Fraser House
36 Charlotte Street,
Manchester M1 4FD
2022-1008M

Proposed GA Second Floor
Ceiling Plan

PLANNING ISSUE

2022-1008M - 045 C

2nd Floor Proposed Ceiling Plan

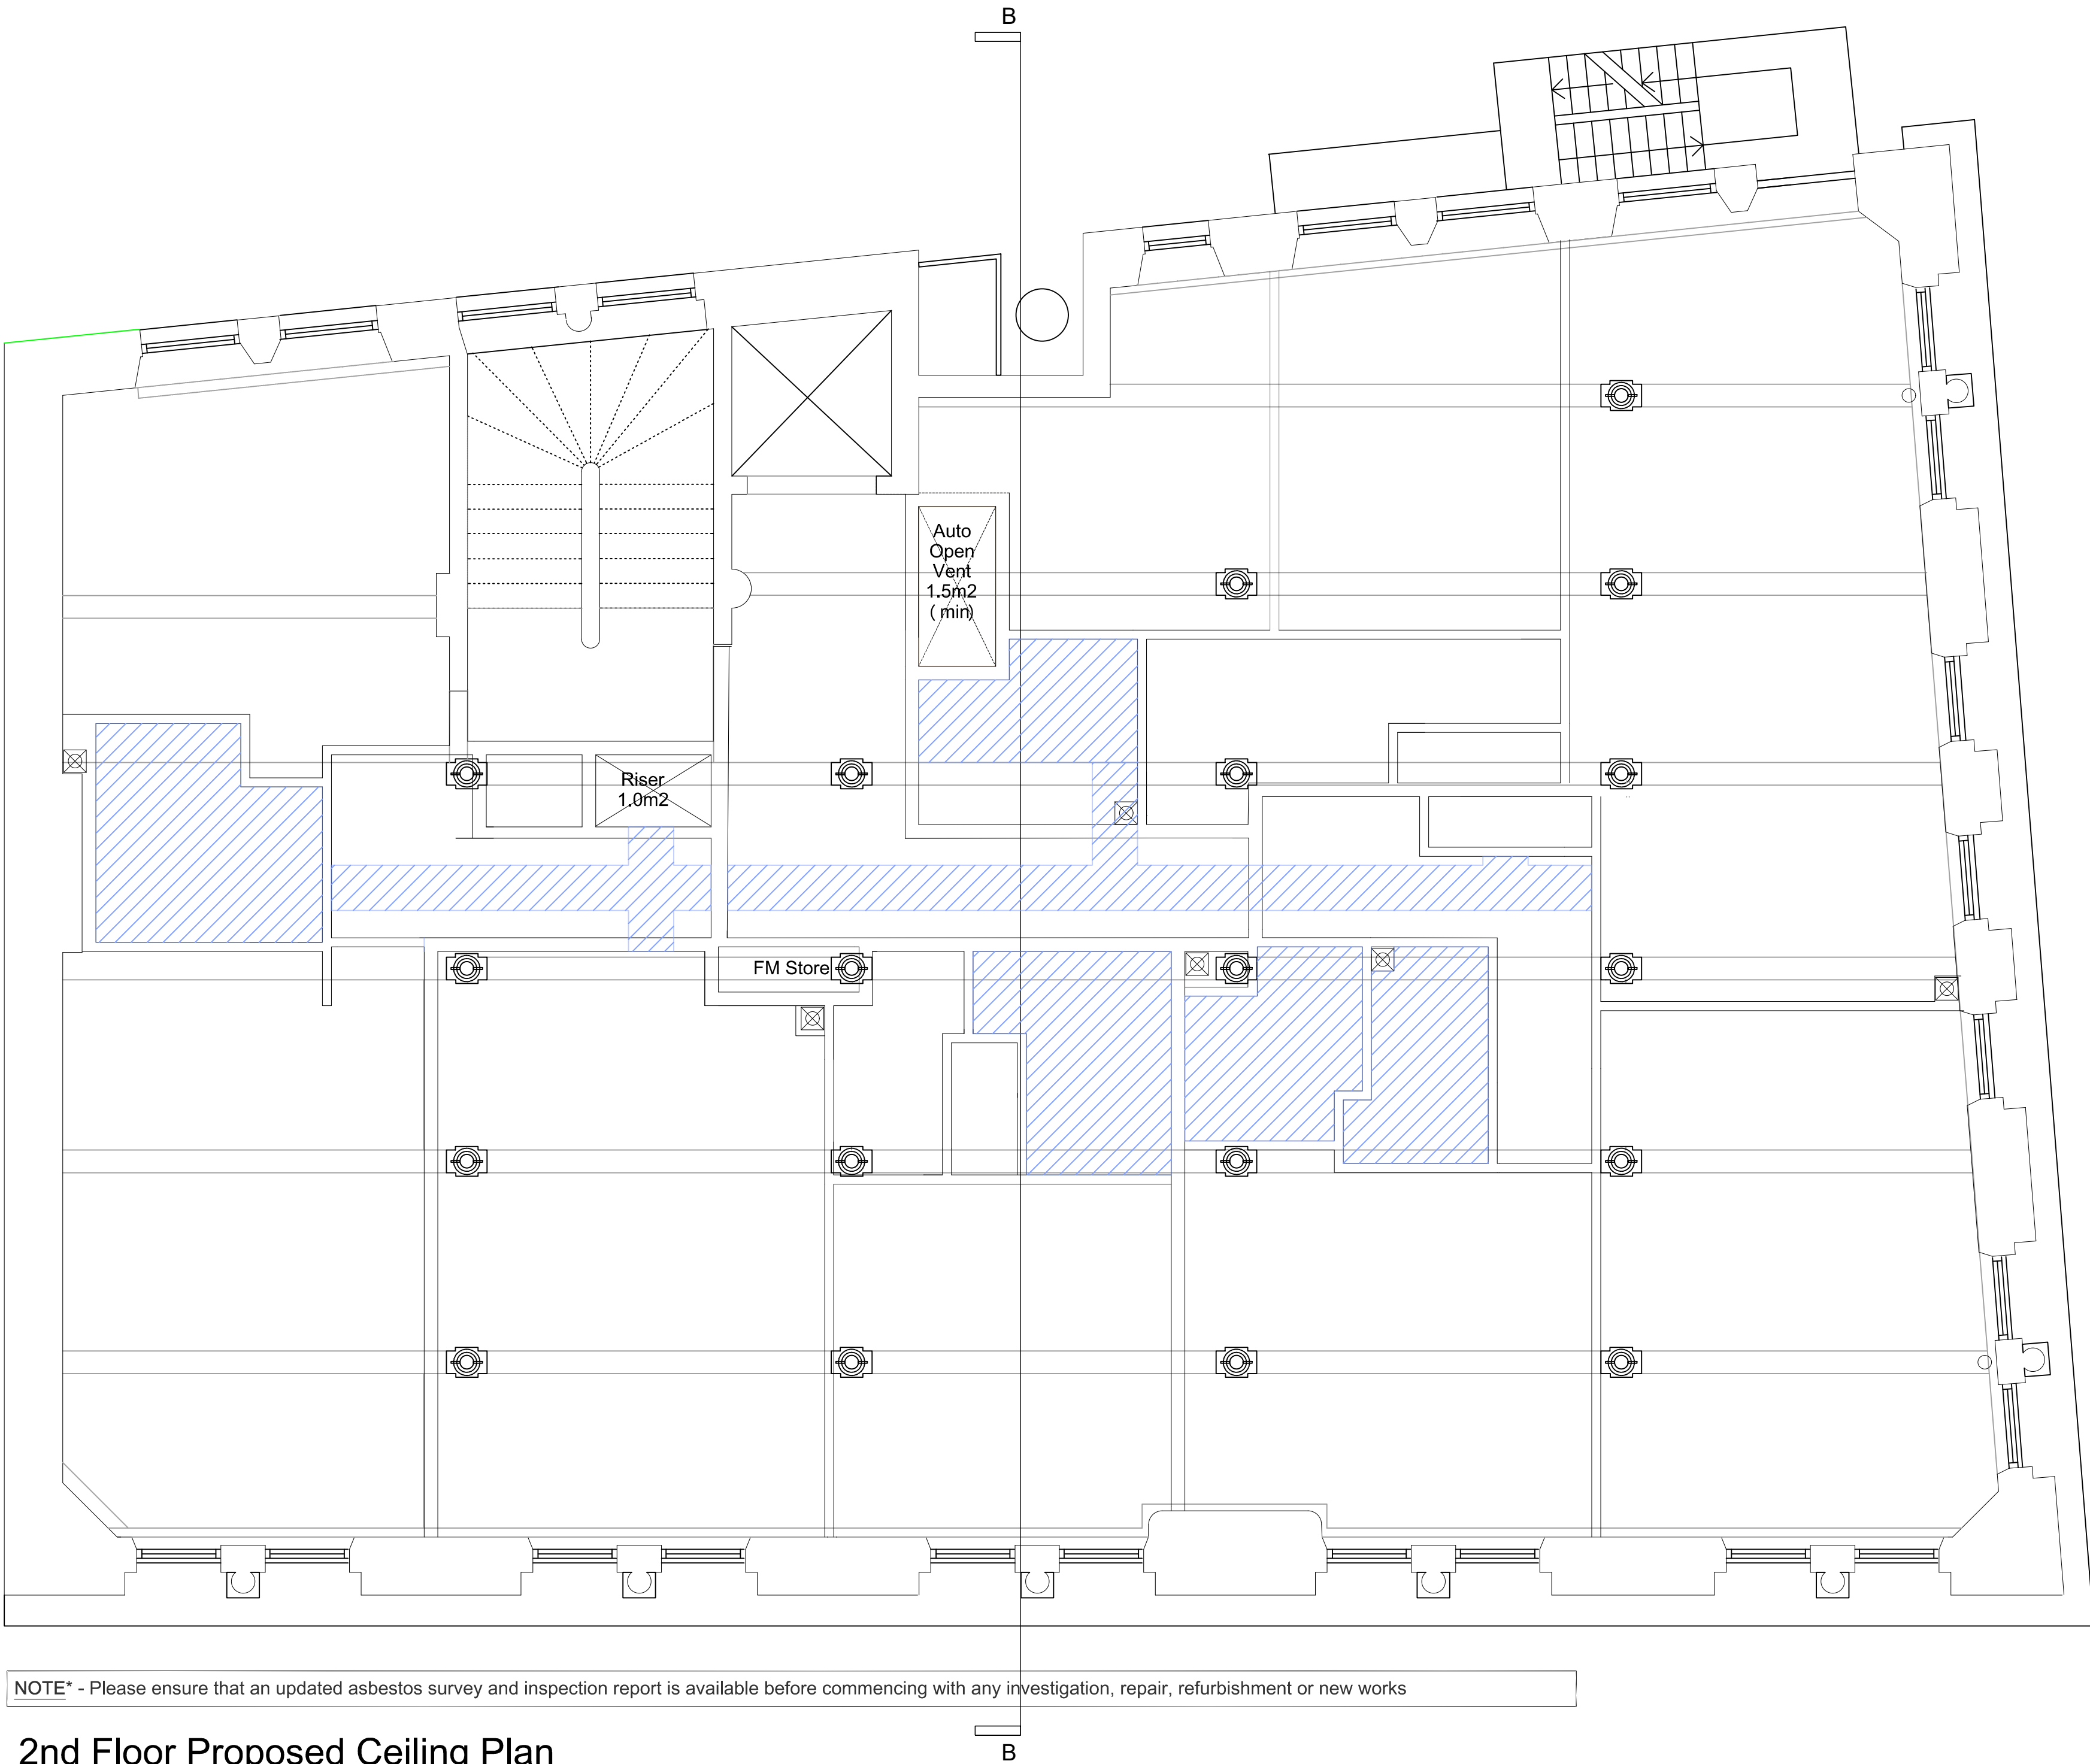
Revision C:
Drop ceiling has been reduced to only bathroom areas.
Suspended cable trays replaced drop ceilings in
corridor and communal areas for power distribution and
corridor lighting
